PERMIT MODIFICATION REQUEST FOR EFFLUENT COMPLIANCE SAMPLING AT 200 AREA
EFFLUENT TREATMENT FACILITY (STATE WASTE DISCHARGE PERMIT, NO. ST 4500)

200 Area Effluent Treatment Facility
State Waste Discharge Permit No. ST 4500
Permit Modification Request for Effluent Compliance Sampling
April 1996

Permit Modifications

Figure 1
Verification Tank Schematic

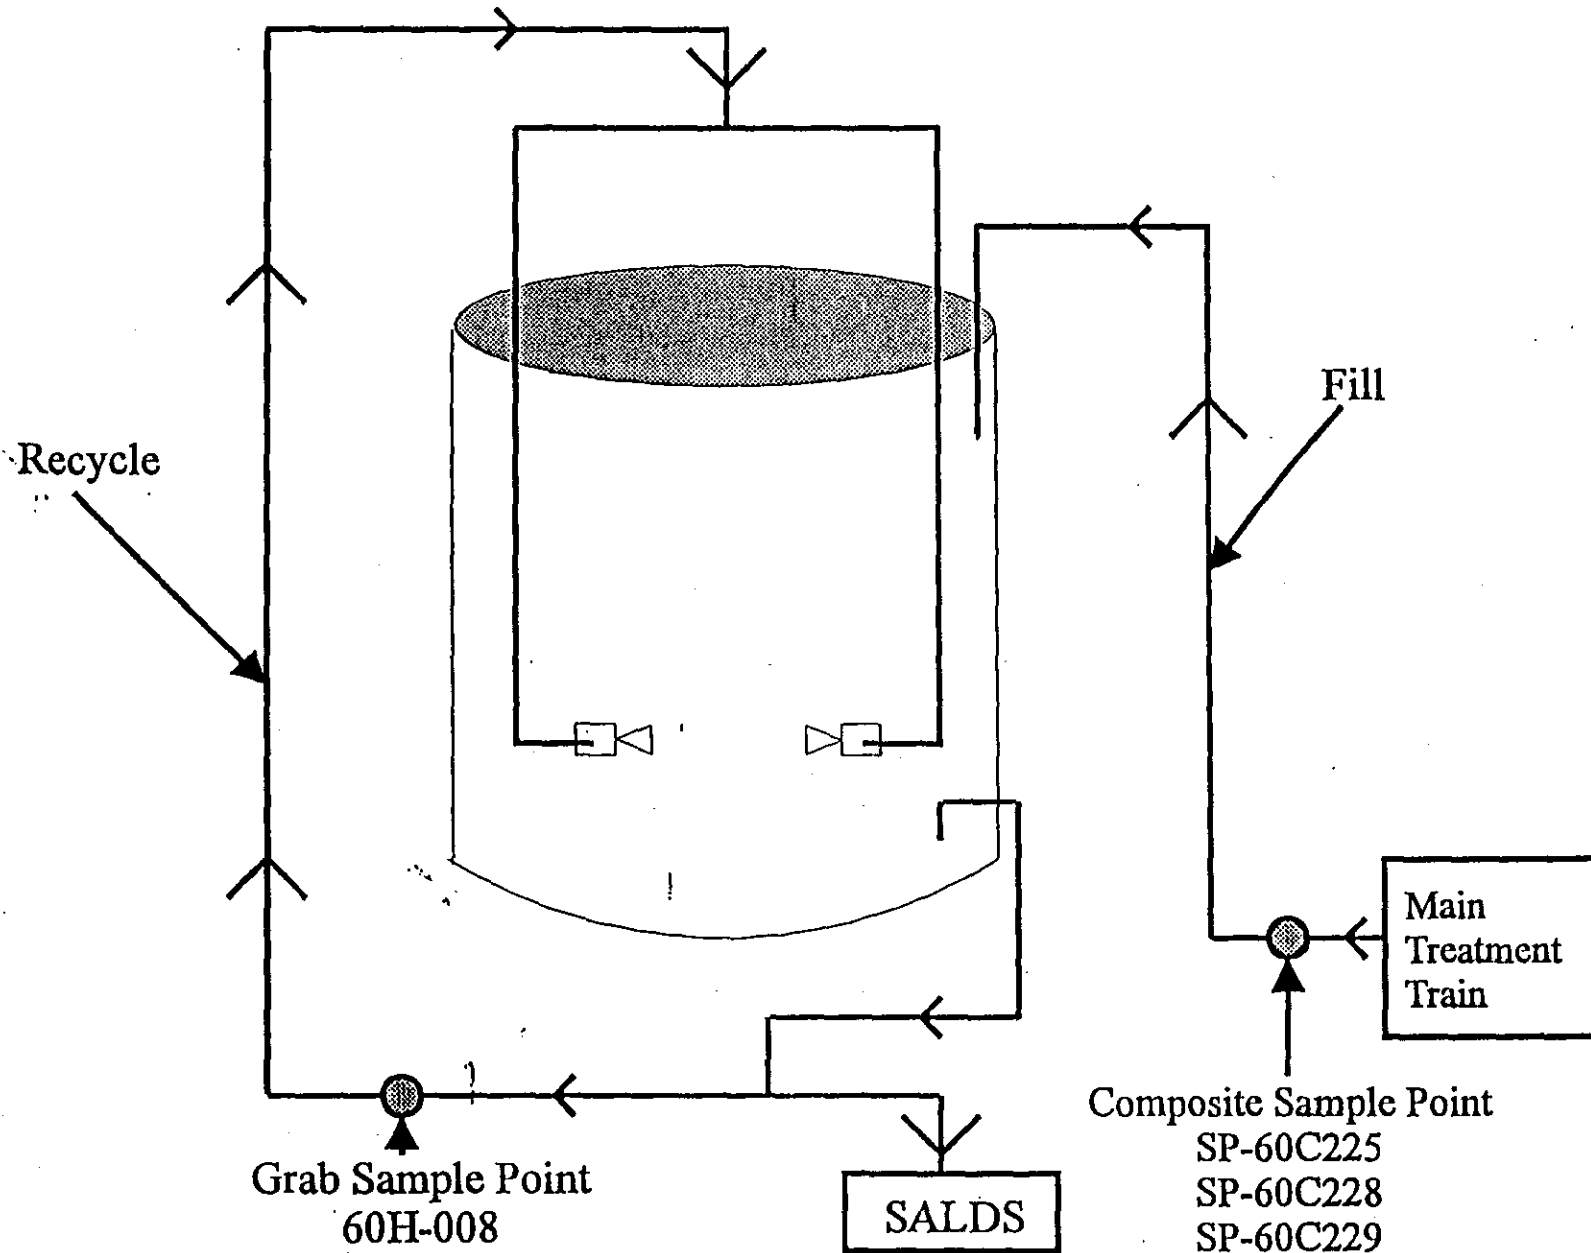
As an alternative to the composite sample, RL proposes to collect a grab sample from the verification tank recirculation line (Figure 1). This line draws 150 gallons per minute from the bottom of the tank and returns the flow back to the tank through two eductors. Though the wastewater sent to the verification tank has little variability, this mode of operating the verification tanks provides a final equalizing or mixing step.

In summary, RL proposes to collect grab samples from the verification tank recirculation line as an alternative and/or backup sample location to determine compliance with the limits contained in the discharge permit. This sample will be collected after the recycle line has been in operation for a minimum of one hour. RL considers a sample collected in this manner to be representative of the discharge that is monitored for compliance with Condition S.1. RL also considers these samples to be in compliance with the requirements of Condition G.11 of the discharge permit.

1. Condition S.1.B, paragraph 1: Revise the first sentence to read, "ETF effluent (Discharge 001 Effluent) shall not exceed the following highest allowable concentrations."
2. Condition S.1.B, footnote 6: Revise the footnote to read, "As measured in the verification tank recycle line or in a composite sample prior to the verification tanks."
3. Condition S.1.B, footnote 8: Revise the second sentence to read, "This includes results from the verification tank."
